**PRODUCT CHANGE NOTICE**  
**PCN Form (D4-E000-73)**

**PCN#11-017**

**YSF Series** (see specific models below)

### YSF Model Series Footprint Compatibility Original vs New

**Figure 1 - Existing Outline Drawing (DL1020)**

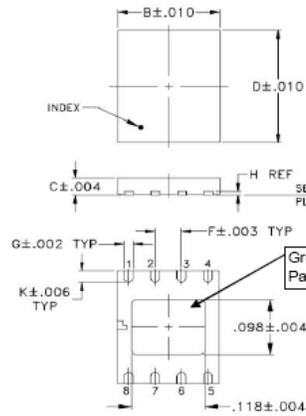
- Change of device footprint (No change to existing overall dimensions)

- No change in function.
- Ground paddle dimension increased per attached drawings.
- No impact on assembly. Footprint is reverse compatible with previous layout

**Figure 7 - Assessment of Original Case Style unit mounted on New PCB Land Pattern**

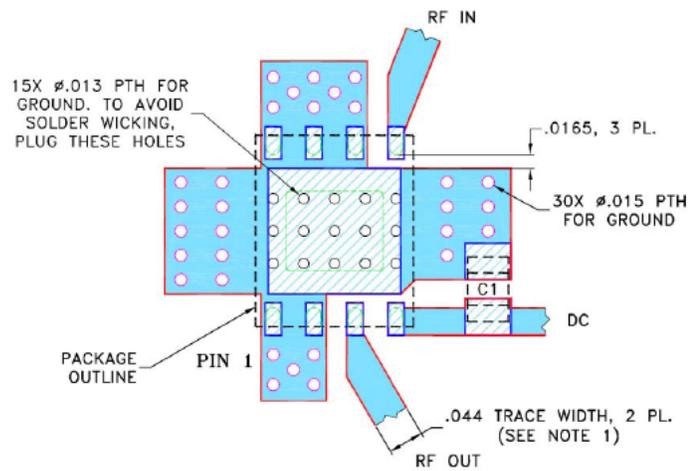
The compatibility of the new case style (DL1636) to the existing PCB layout (PL-335) and of the existing case (DL1020) to the new PCB Layout (PL-352) was assessed in accordance with IPC requirements.

**CONCLUSION:** Both combinations (old case on new PCB Layout – and - new case on old PCB Layout) are compliant with IPC requirements

**Figure 11:** PCB pad after prying the reflowed unit from the board  
(No evidence of shorts)

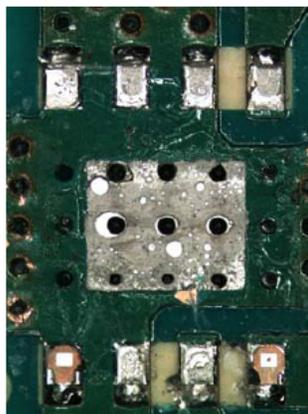
1. New case style YSF units (DL1636) were reflowed onto a PCB with original PCB Layout (PL-335).
2. Reflow conditions were: 245°C peak temperature,
3. Units were additional 4 times. (see flow chart in Figures 12)
4. Units passed Electrical test (DC) after reflow
5. On forcible removal of a unit from PC board, no evidence of bridging between pads was observed, see figure 11.
